Report to Planning Committee 14 March 2024

Report Summary			
Application Number	23/02117/S73M (Major)		
Proposal	Application for variation of conditions 03, 04, 05, 06, 08, 015, 016, 017, 019, 021 and 024 as per submitted schedule attached to planning permission 20/01007/S73M; Variation of conditions 4, 5, 6, 8, 19 and 24 attached to planning permission 17/01586/FULM to amend the approved plans		
	The original proposal was: 12/00301/FULM – Mixed use development comprising demolition of two former industrial buildings, the erection of 11 dwellings, erection of private health facilities, extension to existing Marina comprising new moorings and creation of a wildlife park. Demolition of two industrial buildings.		
Location	Land off Mill Gate, Newark		
Applicant	Cairns Heritage Homes Ltd	Agent	Guy St John Taylor Associates Architects Ltd
Web Link	23/02117/S73M Application for variation of conditions 03, 04, 05, 06, 08, 015, 016, 017, 019, 021 and 024 as per submitted schedule attached to planning permission 20/01007/S73M; Variation of conditions 4, 5, 6, 8, 19 and 24 attached to planning permission 17/01586/FULM to amend the approved plans Land Off Mill Gate Newark On Trent (newark-sh

Plot 2

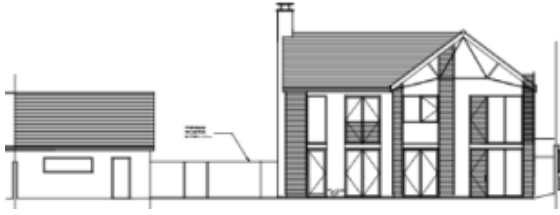
The original plans submitted with this application sought to water down the design approach, a matter which has attracted local objections (as can be noted within the representation section of this report) and was a concern of officers. In response, the scheme has been amended to reinstate the important features, such as the chimneys, the decorative steel eaves detailing and the materials palette has been amended to comprise Spanish slate roof tiles, timber cladding, monouche render and aluminium framed windows and doors. These amendments (including the revised material palette) are considered to be appropriate for the conservation area and help reinstate the original design envisioned.

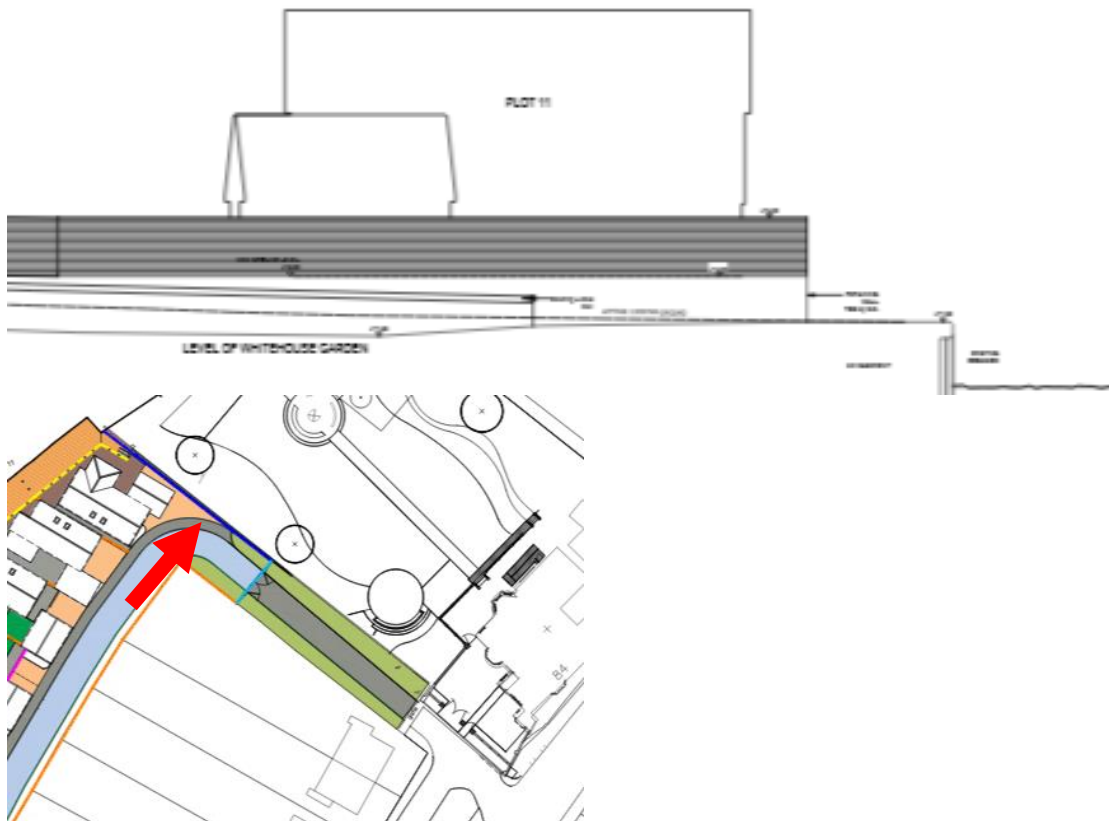
A retaining wall would sit in front of the plots facing the river. This retaining wall (type A on the plans) would remain similar to previously approved but would now comprise blue engineering bricks with 1.1m high railings atop with a stainless steel satin finish. In this context of contemporary development, the detail of the wall is considered appropriate. Part of the frontage of Plot 3 (which has its private garden fronting the river) would be enclosed by a low retaining wall atopped with a timber post fence, which is again considered appropriate. How this might appear is depicted on the image below.

Post and rail timber fencing (type C on the plans) at a height of 1.1m is proposed between Plots 1 to 3 and the riverside park which is considered appropriate.

The private gardens to the plots would, in the most part, be enclosed by 1.8m high horizontal cedar boarding (types C and D) which are relatively discreetly located, being set back generally and lacking prominence. These are considered acceptable. One exception are the boundaries between plots 1, 2 and 3 which would need to comprise a retaining wall (of varying heights to follow terrain) which would comprise blue engineering brick atopped with 1.8m high horizontal cedar board fencing. These retaining structures would be visible through the post and rail fencing of the wildlife park but are considered to be appropriate given the contemporary material palette and given the approved soft landscaping within the park would help to soften this over time.

Extract from originally approved plan from 12/00301/FULM Streetview image of the land in question

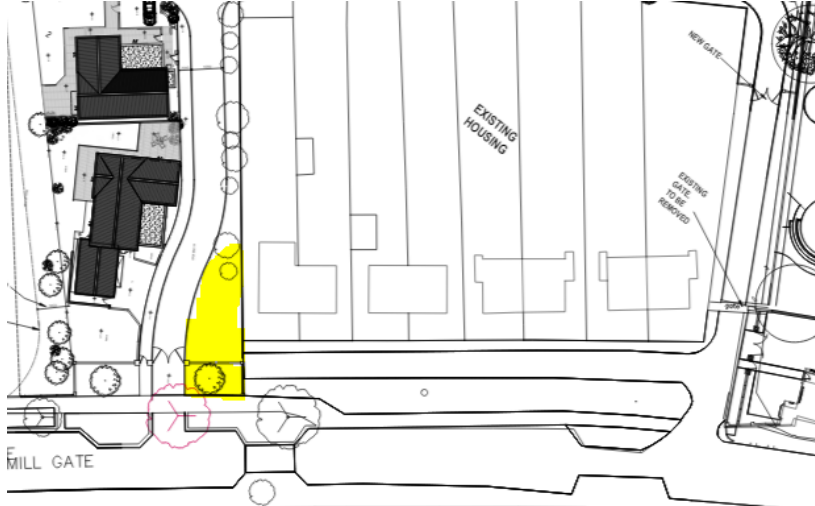
Representations have been made during the course of the application to indicate that the land adjacent to 96 Millgate is currently used by residents as a turning point for vehicles. One such representation indicates that the adjacent property (no. 96) has a deed of easement over the land which means they are responsible for its maintenance and that it wasn't included as part of original plans.

Firstly as already set out, the land in question was contained within the application site as part of the original/host application ref: 12/00301/FULM. At that time the land in question was shown as a rectangular square on the plan (see extract below with area highlighted in yellow) albeit the plan is not annotated to indicate how this was to be treated. It should be noted that the easement location is within the area in highlighted yellow albeit its extent is not known.

Secondly, a right of easement is a civil matter that is not something that the LPA is able to involve itself in and the owners of number 96 (and anyone else with an easement) would need to take this up with the land owners.

This was considered previously, and whilst not ideal for it to no longer be available, all properties (potentially other than number 96 with which an easement is associated) have been taking advantage of the turning ability afforded by this area rather than having a right to use it and its removal therefore does not change the current situation.
